PENNLEY PARK SOUTH DEVELOPMENT - BLOCK A

FINAL LAND DEVEOPMENT PLAN
PITTSBURGH, PENNSYLVANIA

NOVEMBER 26TH, 2018
REVISED JANUARY 28TH, 2019
REVISED FEBRUARY 7TH, 2019

Re: CDAP Summary for Pennley Park South

ELEVATION - EUCLID AVE

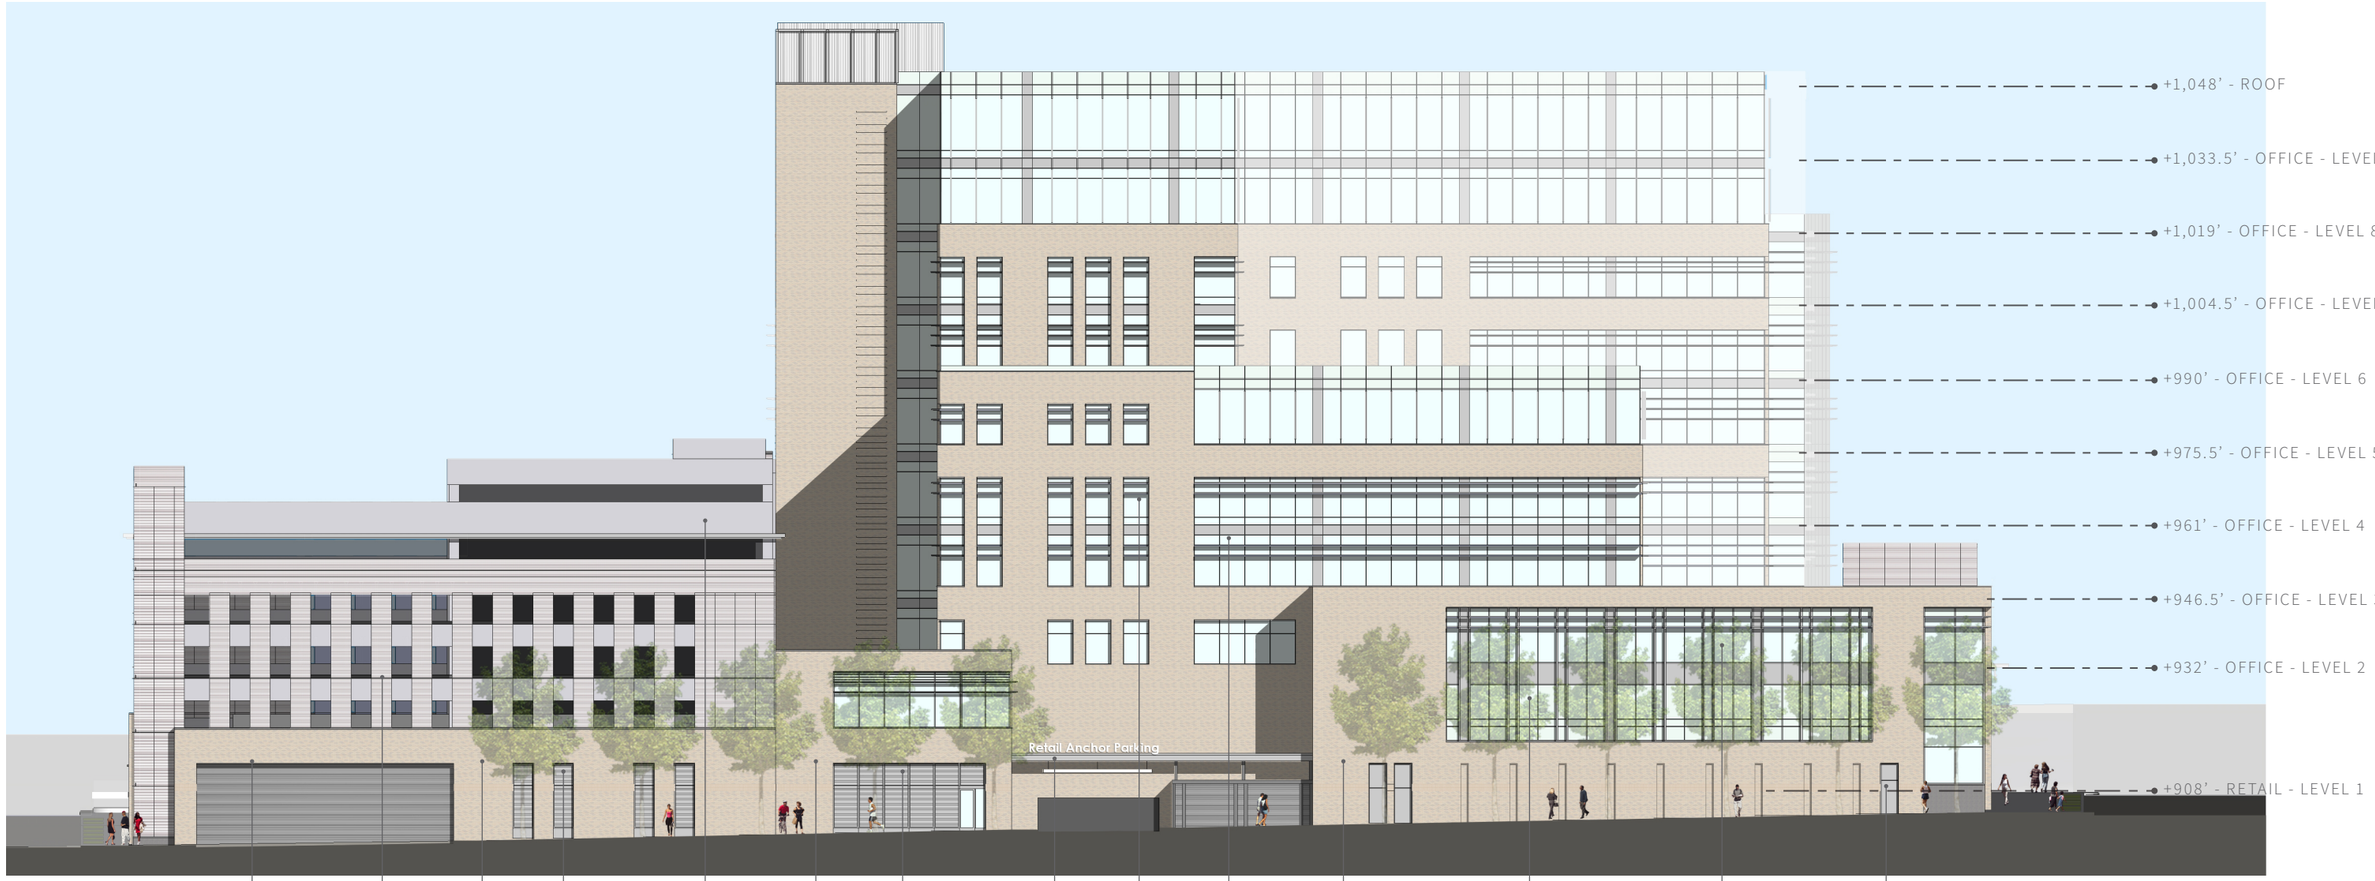
- Continue to refine the corner massing at S Euclid and Penn Avenues. The Panel noted that this is an important corner and neighborhood gateway for the overall development. In particular, explore means to further break down the massing or to further articulate this corner.

MV+A Response: The corner massing is a subset of the overall building massing and is sized similar to the existing buildings at this intersection. The massing is further articulated by large openings in the masonry patterned with a composition of opaque metal panels, transparent glass and projecting sun shading devices. Breaking down the massing further will have the adverse impact of obliterating the corner presence established by the current design.
